Re: Comments on Behalf of The Marine Group LLC and BAE Systems San Diego Ship Repair Inc. on the Proposed Plan for the Portland Harbor Superfund Site

The Marine Group LLC (TMG) and BAE Systems San Diego Ship Repair Inc. (BAE Systems) submit the following comments to EPA's Proposed Plan (PP) for Portland Harbor Superfund Site¹ (Site). The U.S. Environmental Protection Agency, Region 10 (EPA) has identified both TMG and BAE Systems as potentially responsible parties (PRPs) at the Site in connection with the former operations of Northwest Marine Iron Works, Inc. (Northwest Marine).

Figure 2
TMG and BAE Systems Comments
on the Proposed Plan

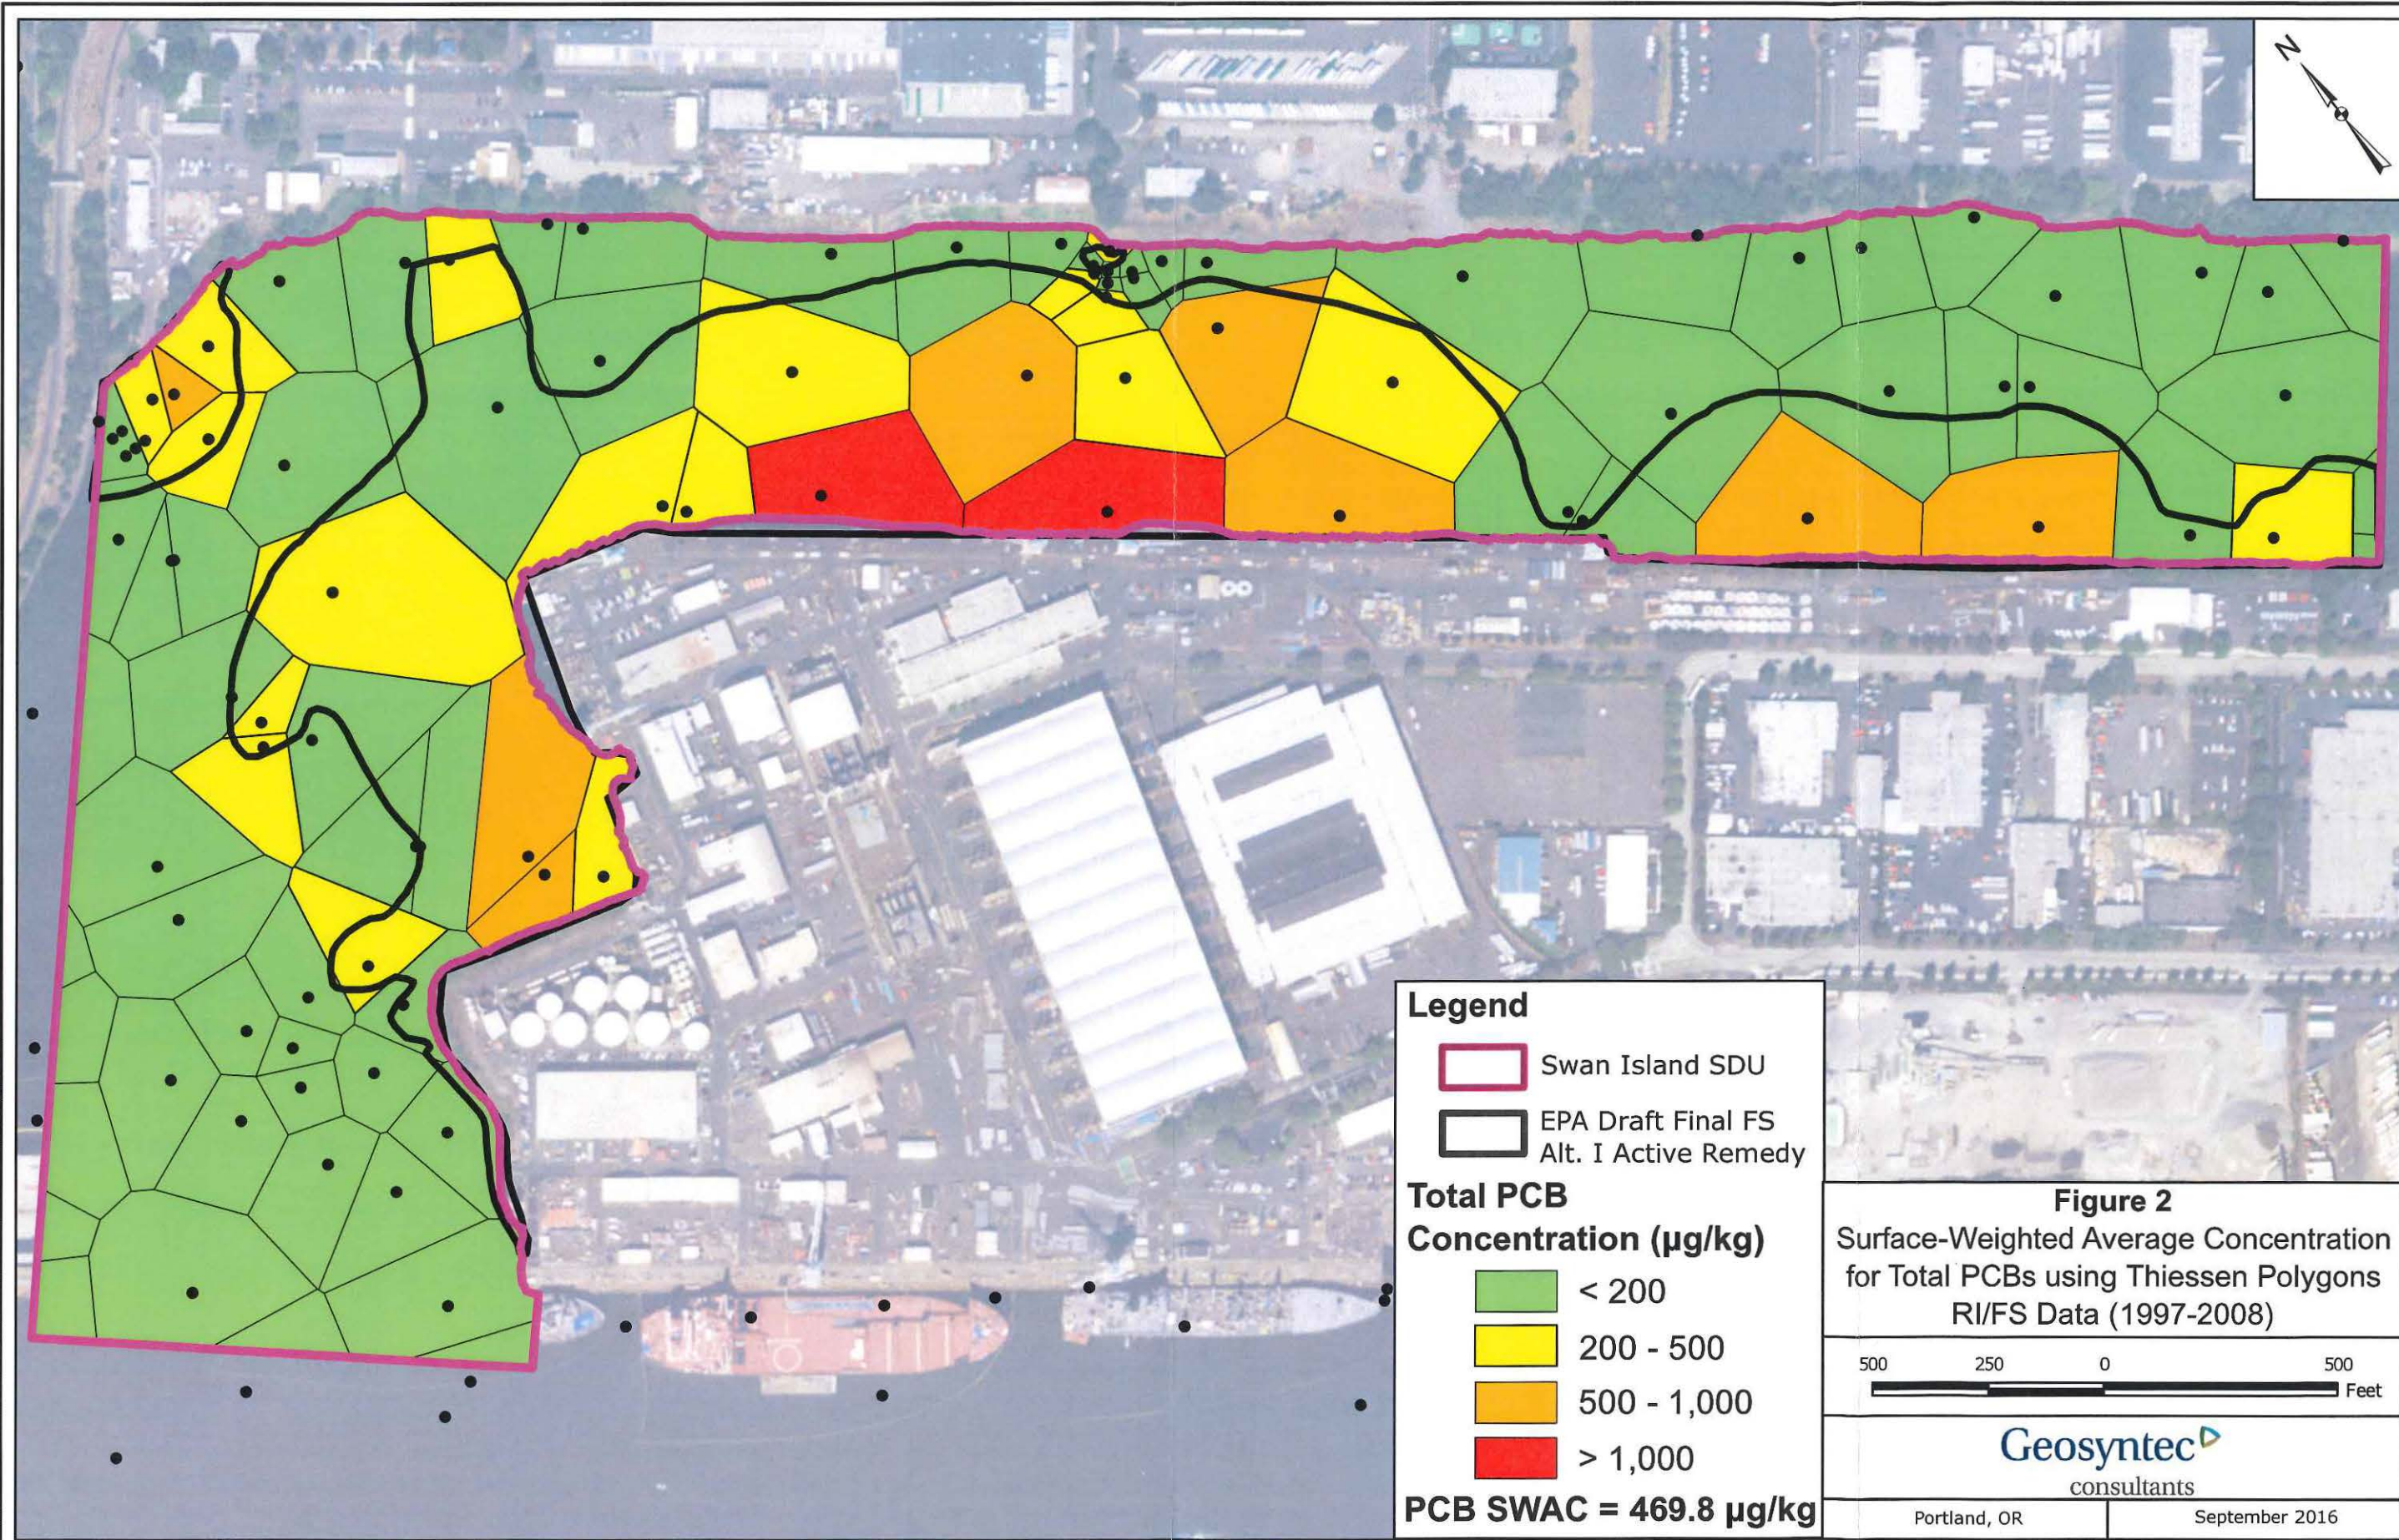
Figure 2 presents the resulting polygons using pre-2014 sediment data from the LWG RI/FS database, and Figure 3 presents the polygons using post-2014 sampling from the two sediment investigations performed in 2014 and 2016 to update collocated sediment samples from the RI/FS database.⁸ The pre-2014 SWAC calculated for the SI SDU is 469.8 µg/kg, whereas the post-2014 SWAC is 166.8 µg/kg. This is a 64.5% reduction.

Figure 4
TMG and BAE Systems Comments
 FIGURE 1
OVERWATER STRUCTURES AND
UPDATED REQUIRED NAVIGATION
DEPTH (SHOWN BY FACILITY), SWAN
ISLAND SEDIMENT DECISION UNIT

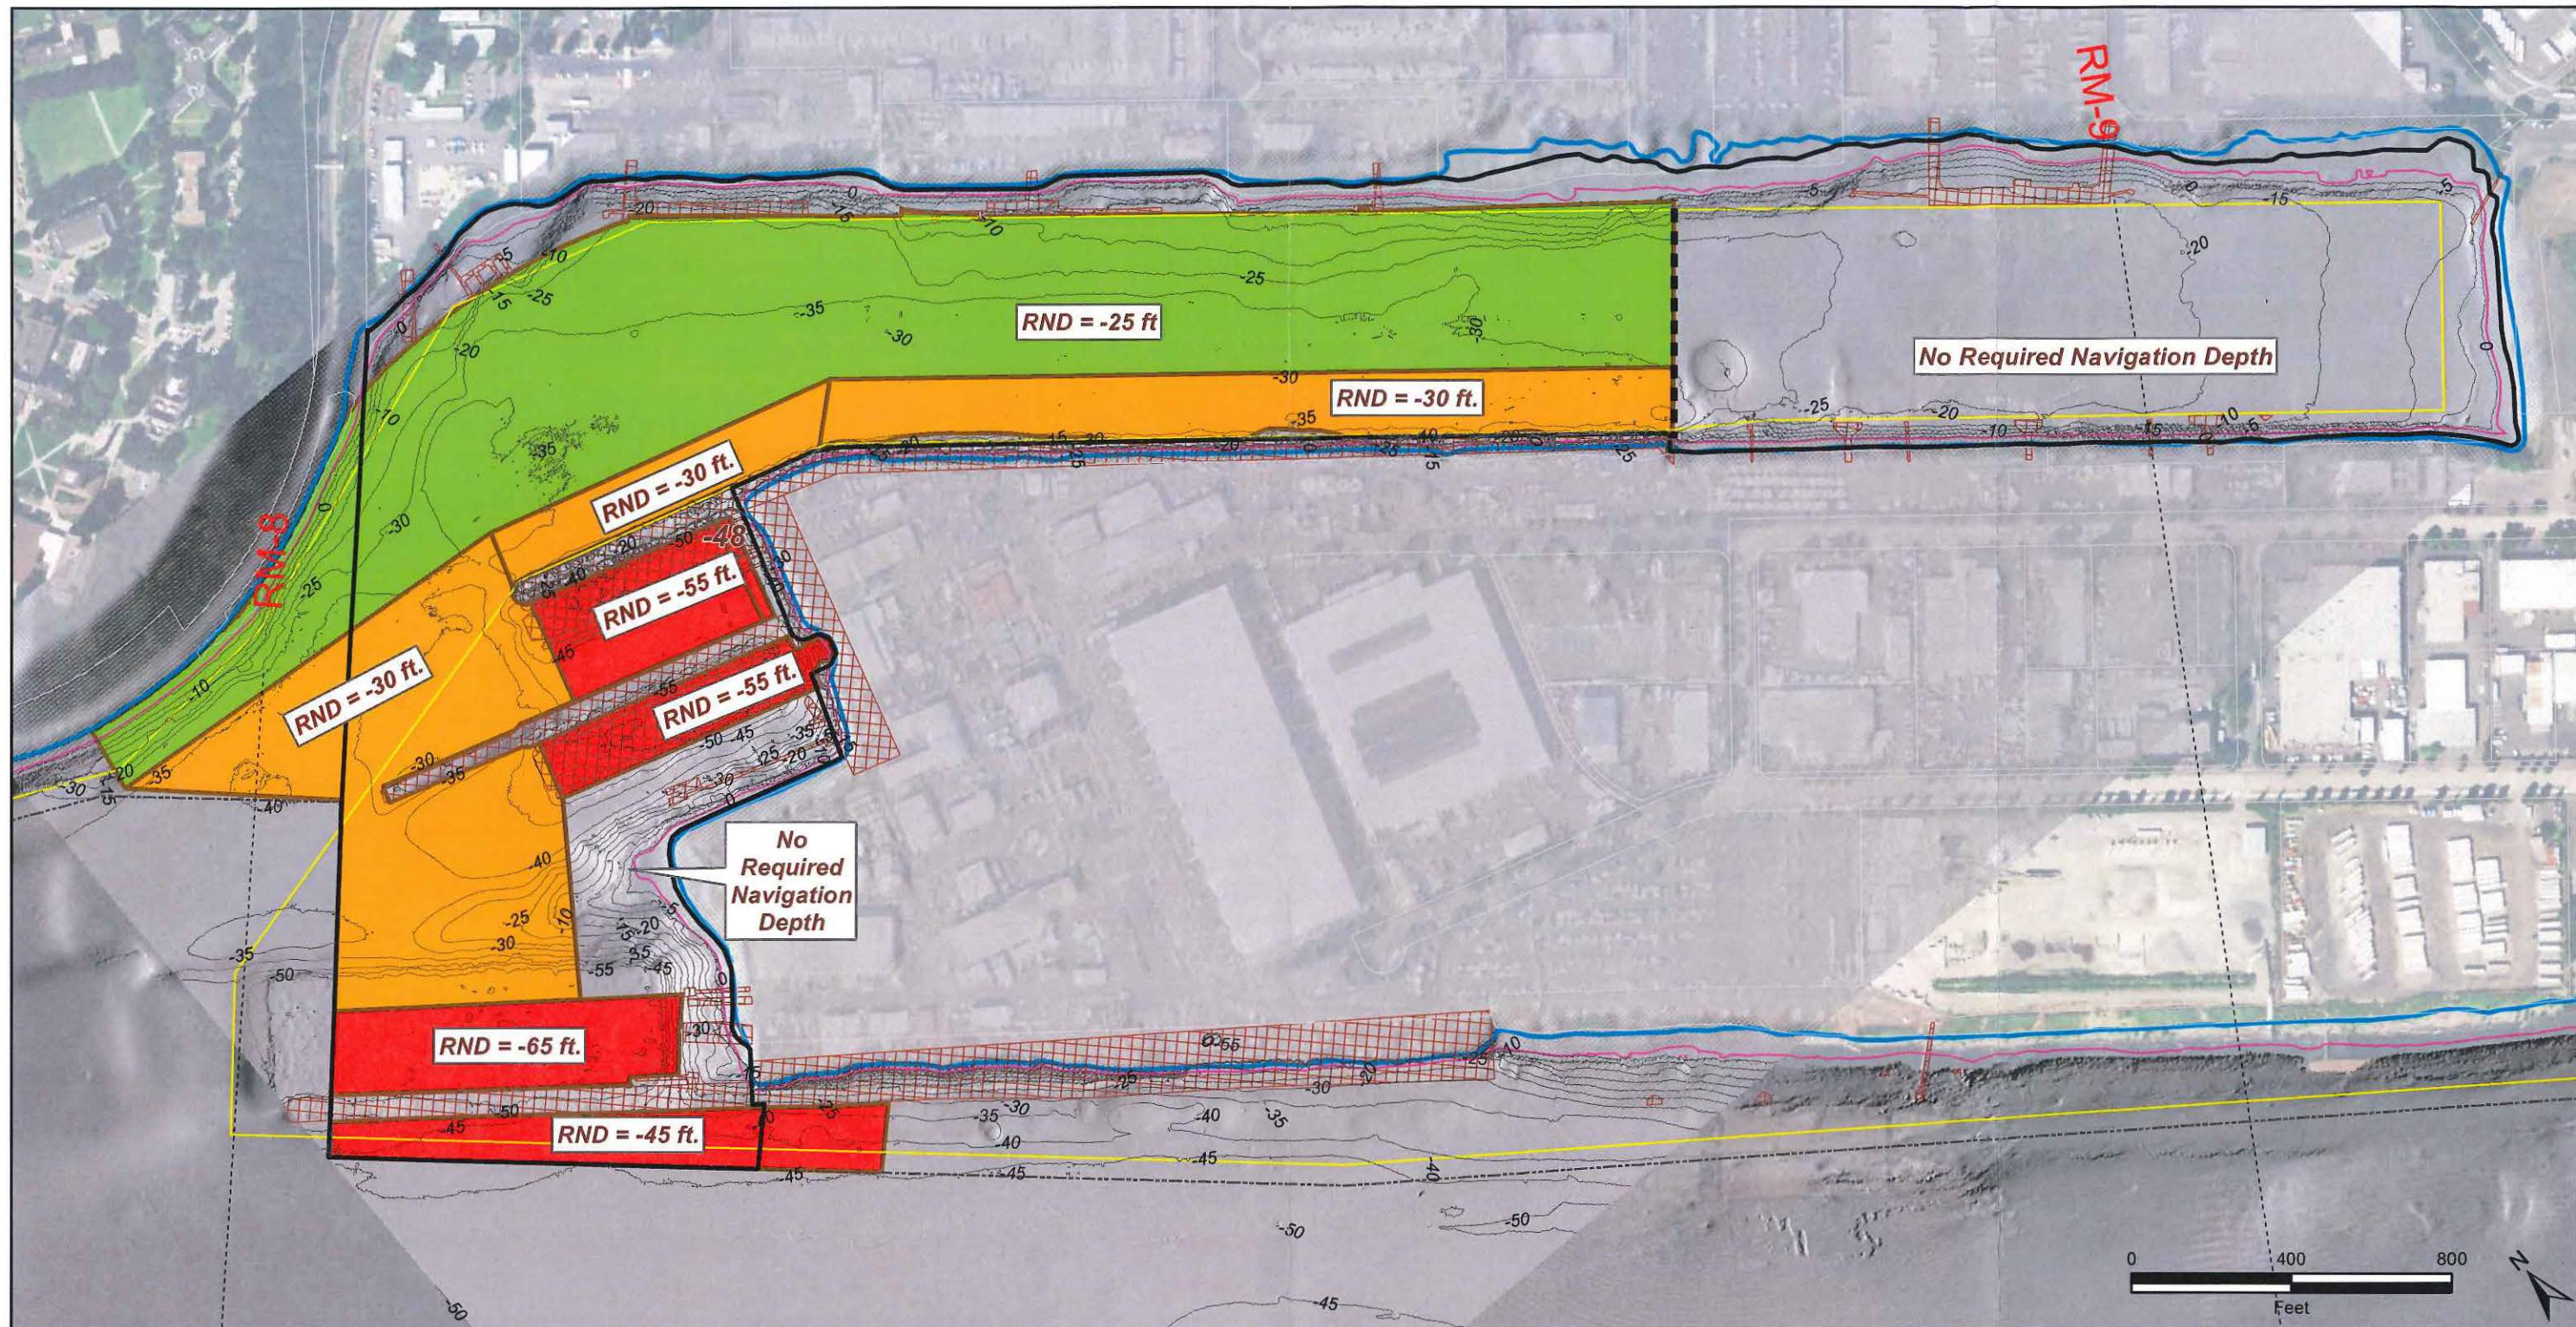
The PRP-provided information about the current and future navigation depth requirements in the SI SDU reveals that very little ongoing navigation maintenance dredging is or will be required or performed in the SI SDU. The actual navigation uses and depth requirements (Figure 4)⁶⁶ differ substantially from the information used by EPA in the PP in terms of both the extent and depth requirements of future maintenance dredging. This updated information indicates that much of the SI SDU should be more accurately characterized as an intermediate zone under the PP's framework.⁶⁷
